MODEL BD-700-1A11 (BD-700)

## MODIFICATION – FLIGHT CREW SEATS – INTRODUCTION OF NEW GOODRICH CREW SEATS

MODEL BD-700-1A11 (BD-700)

## MODIFICATION – FLIGHT CREW SEATS – INTRODUCTION OF NEW GOODRICH CREW SEATS

**PL KGC991-1350** – Kit – Crew Seat Replacement  
 (Sheet 2 of 2, Rev. B)

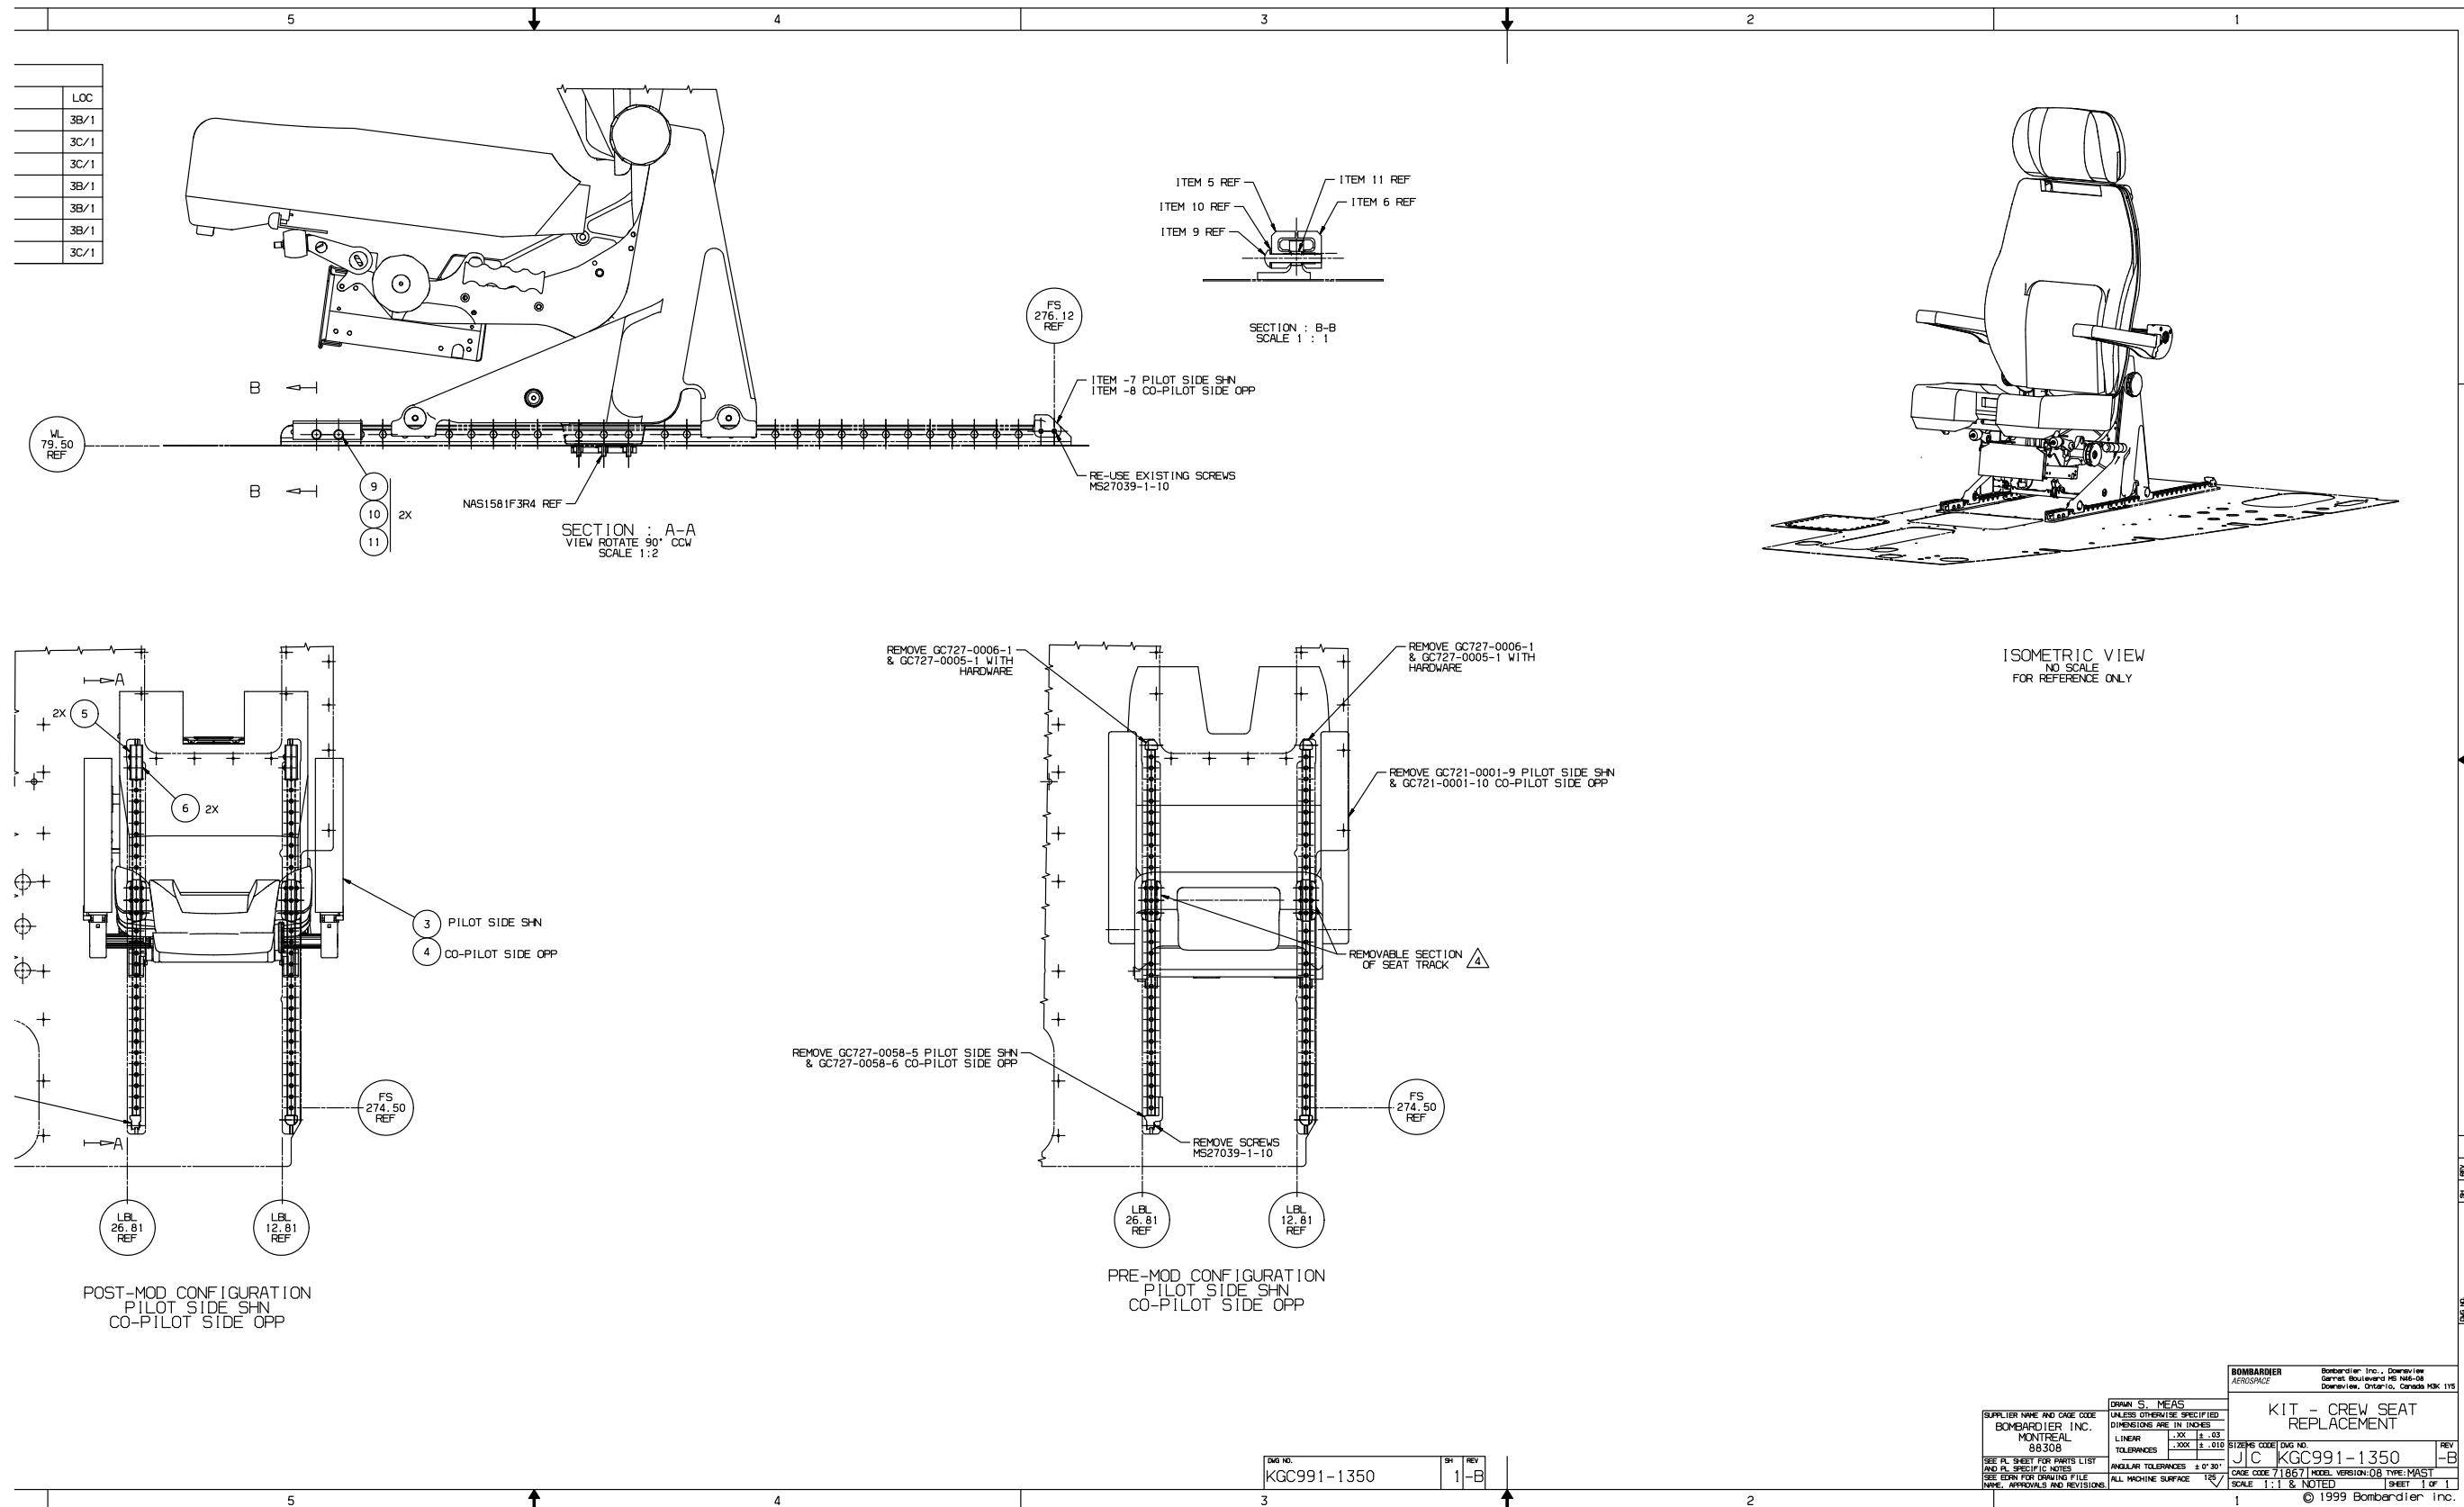
5. CHANGE CREW SEATS AS FOLLOWS (ALL QUANTITIES ARE PER SEAT)
  - (1) REMOVE & DISCARD OLD FWD STOP FITTING QTY(2) (REF : GC727-0005 & GC727-0006) AND ATTACHING BOLTS QTY (2)

- (2) REMOVE OLD AFT STOP FITTING QTY (1) (REF : GC727-0058-5 PILOT & GC727-0058-6 CO-PILOT) AND ATTACHING BOLTS QTY (2), DISCARD OLD AFT STOP FITTING AND RETAIN ATTACHING BOLTS

- (3) REMOVE REMOVABLE SEAT TRACK SECTION QTY (2) (REF : GC727-0059) AND ATTACHING BOLTS QTY (12) AND RETAIN ALL PARTS.
  - (4) REMOVE OLD SEAT AND INSTALL NEW SEAT AT FWD END OF TRACK WITH AFT ROLLER ASSEMBLY INSTALLING WHERE SECTION OF SEAT TRACK WAS REMOVED PER STEP 3

- (6) INSTALL NEW AFT STOP FITTING QTY (1) (REF : GC727-0058-9 PILOT AND GC727-0058-10 CO-PILOT) WITH ATTACHING BOLTS FROM STEP 2
  - (7) REINSTALL ITEMS REMOVED IN STEP 3

- (8) INSTALL NEW FWD STOP FITTING QTY (2) (REF : GC727-7005 & GC727-7006) WITH THE APPROPRIATE HARDWARE

**KGC991-1350 – Kit –Crew Seat Replacement**  
(Sheet 1 of 1, Rev. B, continued)

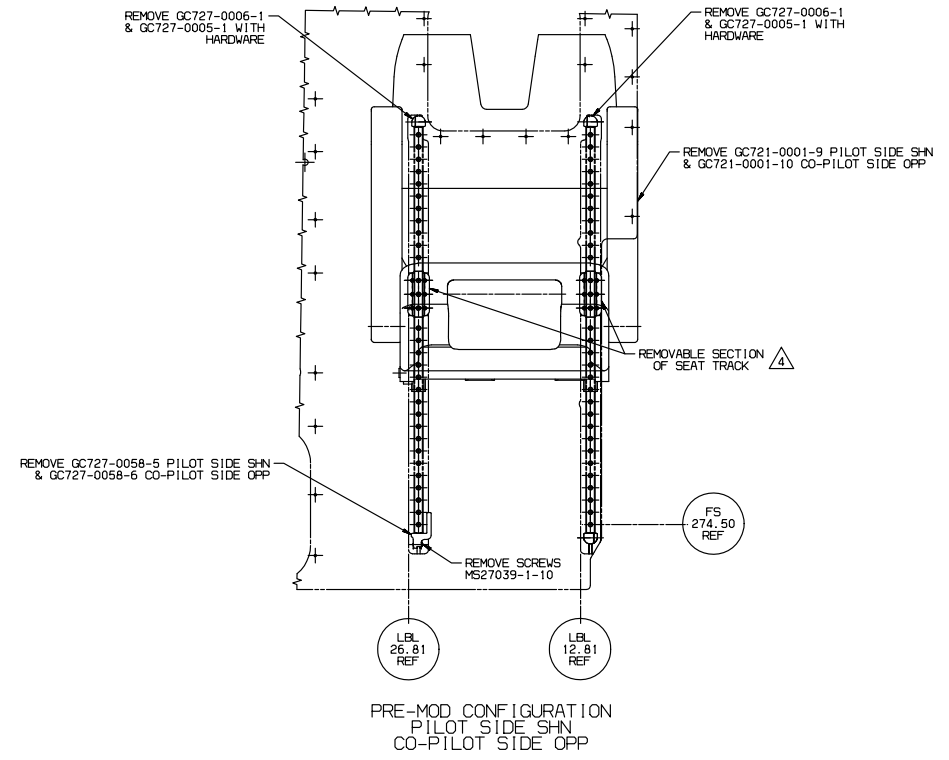
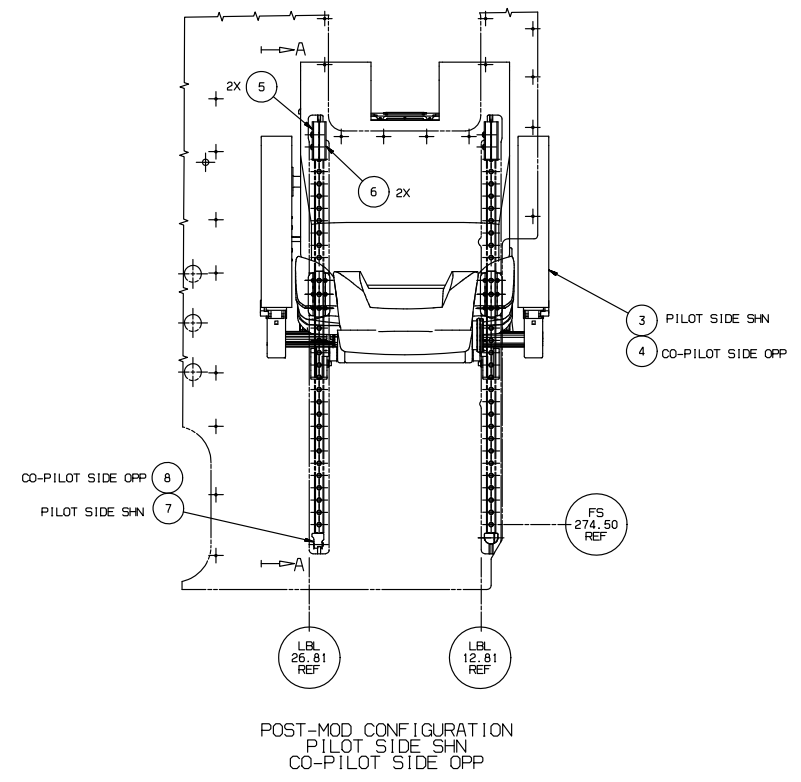
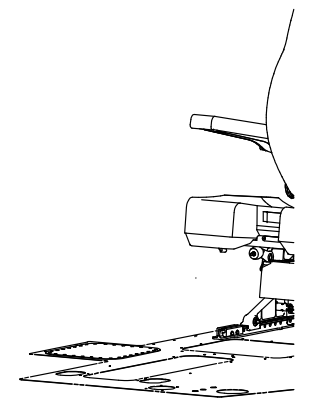
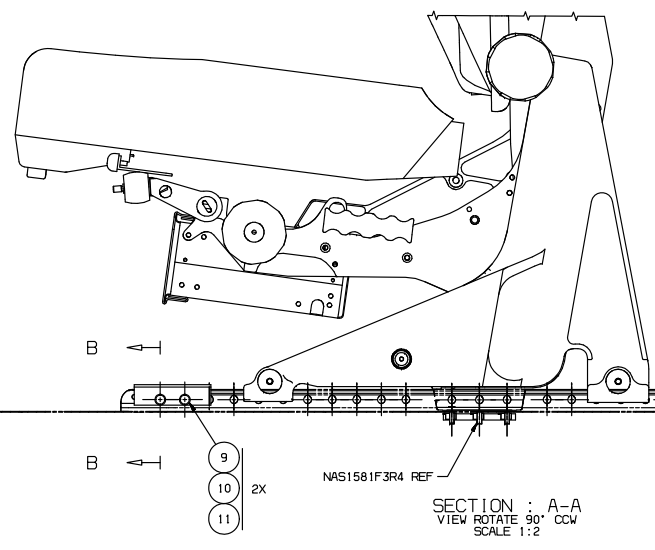
PARTS TO BE REMOVED OR MODIFIED				
PART NUMBER	DESCRIPTION	QTY	DISPOSITION	LOC
GC721-0001	CREW SEAT	2	DISCARD	3B/1
GC727-0005-1	FWD STOP FITTING	4	DISCARD	3C/1
GC727-0006-1	FWD STOP FITTING	4	DISCARD	3C/1
GC727-0058-5	AFT STOP FITTING	1	DISCARD	3B/1
GC727-0058-6	AFT STOP FITTING	1	DISCARD	3B/1
MS207039-1-10	SCREW	4	RE-USE	3B/1
MS207039-1-15	SCREW	4	DISCARD	3C/1
